**To:** Distribution- - see below  
**From:** H. F. McAlpine  
**Date:** October 22 1999  
**Subject:** Dam Safety Assessment of the Mt. Nansen Tailings Dam

**BYG Tailings Dam, Mount Nansen, YT - Site Visit Report**

Figure 1

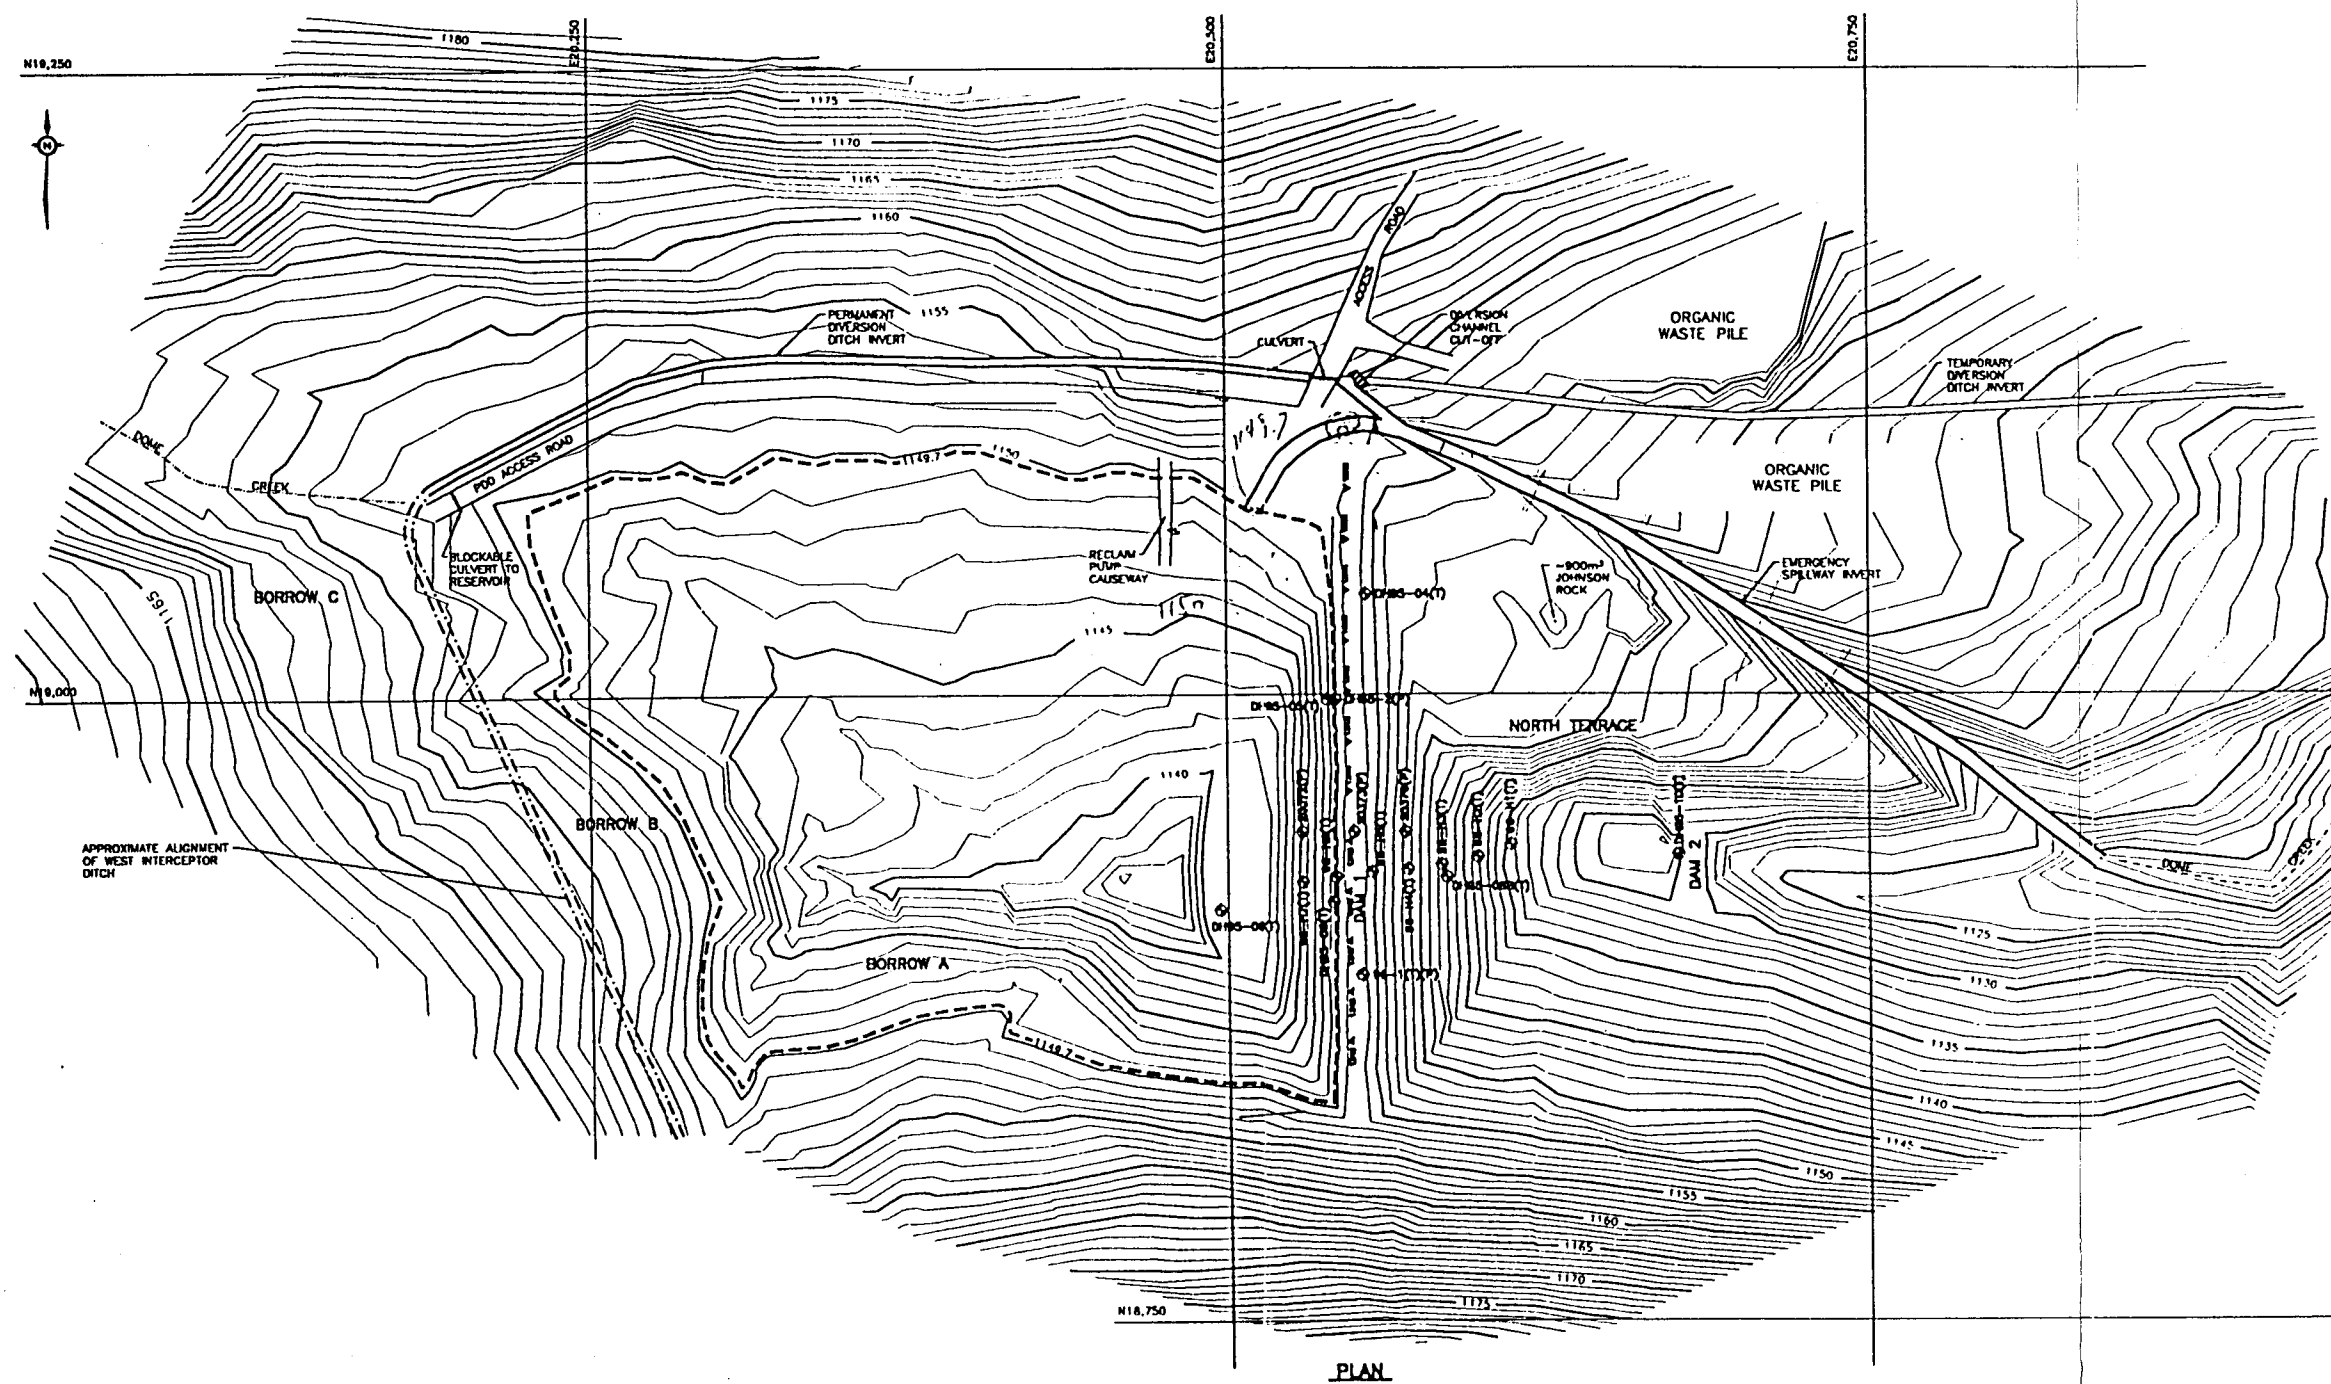
The purpose of this letter is to provide a general impression of the current condition of the BYG Tailings Impoundment (see Photo 1 and Figure 1 for site plan) as well as to identify some issues related to the safety and integrity of the dam that require immediate attention. On September 16, 1999 our Robert Lo visited the site together with yourself, Mr. Cord Hamilton of EBA and Mr. Milos Stepanek of Geo-engineering. This report is based mainly on our observations and discussions on site together with a preliminary review of some recent site monitoring data provided to us through EBA. The letter was prepared in consultation with Mr. Cord Hamilton of EBA. We will carry out a more thorough review as stipulated earlier, but this must not delay initiation of improvement measures given in this letter.

Photograph 10 Emergency Spillway Channel - lower segment (used also for conveying water from North Diversion Ditch).

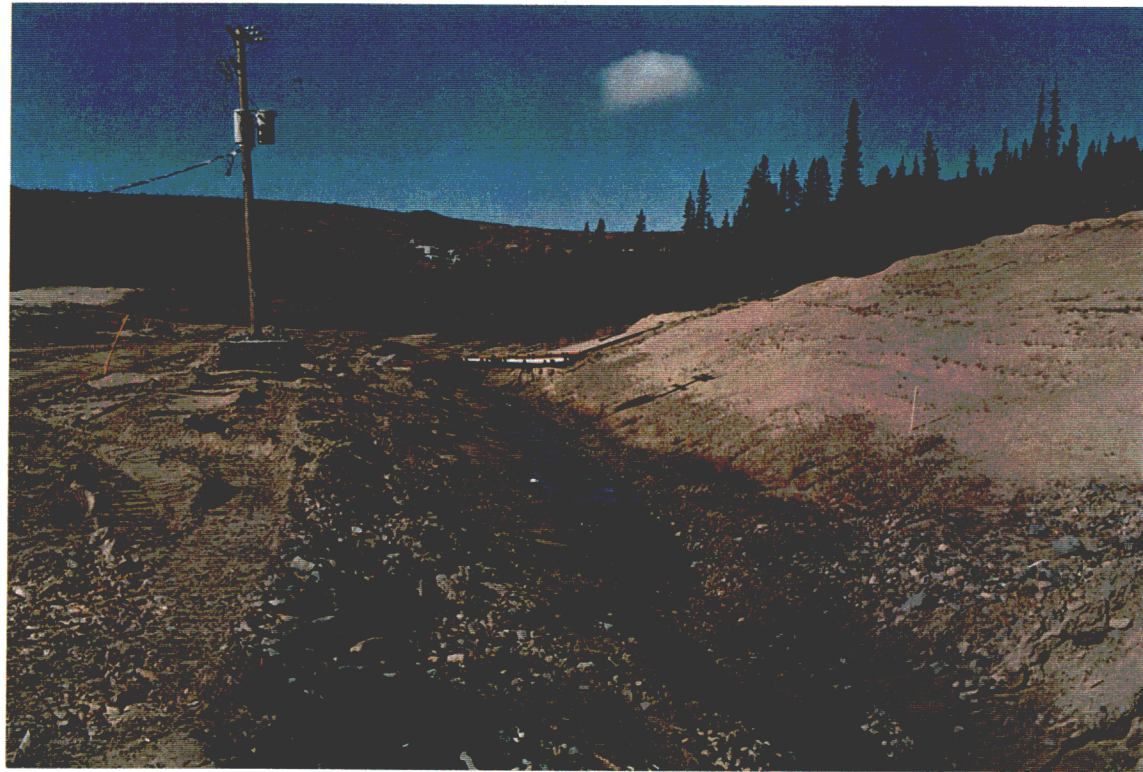
the flow back into Dome Creek downstream of the Seepage Recovery Pond. Its downstream segment shares the channel with the Emergency Spillway outlet channel (see Photos 10 and 11). The extended West Diversion Ditch picks up additional surface runoff along the west perimeter of the tailings impoundment (see Photo 14).

Sand and silt sediments generally covered the channel bottom along the West Diversion Ditch and the upstream segment of the North Diversion Ditch (see Photos 13 and 14). As the gradient increases along the downstream segment of the North Diversion Ditch, the riprap protection reduces the downcutting of the ditch invert. Ongoing erosion and side slope adjustment as well as the maintenance of the slope protection were visible (see Photos 10 and 11).

3. Investigate the existing condition of the emergency spillway channel to check what improvements to the slope protection of the channel may be required. This investigation should be carried out to a downstream point, where the Main Dam will no longer be threatened if the flow jumps out from the spillway channel. A thorough review of the site record and discussion with personnel familiar with the past mine operation by EBA would be a useful initial step.
